SAN FRANCISCO PLANNING DEPARTMENT

Appeal of EIR Certification One Oak Street (1500–1540 Market Street) Project

DATE: August 30, 2017
TO: Angela Calvillo, Clerk of the Board of Supervisors
FROM: Lisa Gibson, Environmental Review Officer – (415) 575-9034
Diane Livia, Environmental Planner – (415) 575-8758
Rick Cooper, Senior Environmental Planner – (415) 575-9027
RE: File No. 170812, Planning Department Case No. 2009.0159E,
Appeal of the Environmental Impact Report Certification for the
One Oak Street (1500–1540 Market Street) Project, Block 0836,
Lots: 001,002, 003, 004, and 005
PROJECT SPONSOR: One Oak Owner, LLC
APPELLANT: Jason Henderson
HEARING DATE: September 5, 2017

FIGURE 1: REVISED PROJECT TOWER SHIFT DIAGRAM

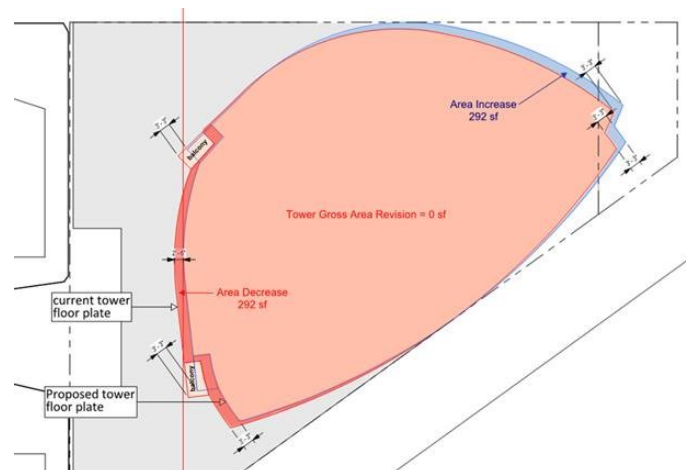
Subsequent to the certification of the EIR, the subject project design was revised ("revised project") from that described and shown in the certified EIR¹. As shown in **Figure 1: Revised Project Tower Shift Diagram** of this memorandum, the revised project would shift the tower element of the proposed building (floors 13-40) 3.25 feet northeastward within the building site, parallel to the Market Street property line. With this shift, the westernmost 2.5 feet of the tower element, which would have been within a 120-R-2 Height and Bulk District, would be shifted outside of that district into the existing 120/400-R-2 Height and Bulk District. Accordingly, the entire tower element under the revised project would then be within the existing 120/400-R-2 Height and Bulk District. The revised project would not require any legislative amendments to the height and bulk districts within the project site.²

The northeastward shift of the tower element would be accompanied by a corresponding northeastward elongation of podium floors 4-12 by 3.25 feet, resulting in an increase to these floorplate areas of about 292 sq. ft. at each of the nine podium floors 4-12 (or about 245 gross square feet ["gsf"] of residential use per floor, totaling 2,205 gsf under the revised project). The increased area would not affect the residential unit count or the bedroom unit mix studied in the EIR. Rather, it would increase the room sizes at the eastern perimeter of floors 4-12.

The design revisions would not call for any change to the dimensions and configuration of podium levels 1-3 nor would they require any changes to the proposed site plan. Rather, the cantilevered overhang above the triple-height window wall at the eastern “prow” of the proposed building would be extended further northeastward by an additional 3.25 feet to accommodate the elongation of podium floors 4-12.

We are writing in connection with the recent notification received by BMT that confirms some minor changes to the position of the Tower. We understand that the key change, as indicated in the figure below, is the Tower shifts to the northeast by approximately 3'-3" along the Market Street property line axis, which results in an approximate 2'-6" shift to the east and 2'-1" shift to the north.
